Serial No. 10/588,007

Amendments to the Drawings

REMARKS

Fig. 7

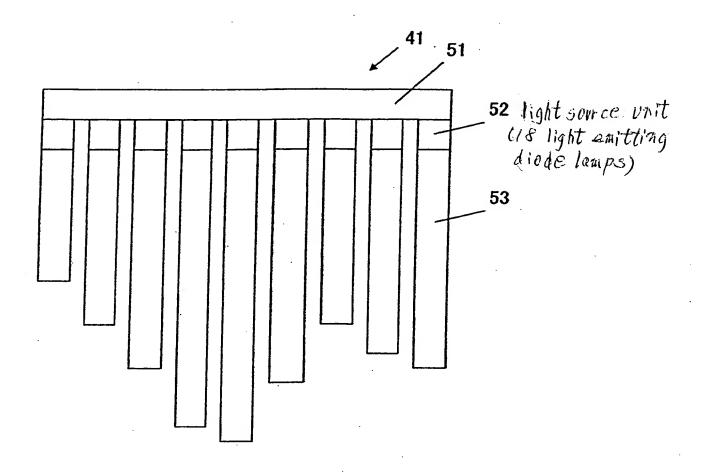
In Fig. 7, add --light source unit (18 light emitting diode lamps)--.

In regard to the drawings, Fig. 7 has been amended to specify that each lamp unit has 18 light emitting diode lamps, which is disclosed on page 25, lines 2-4 from the bottom of the specification. Please withdraw the drawing objection.
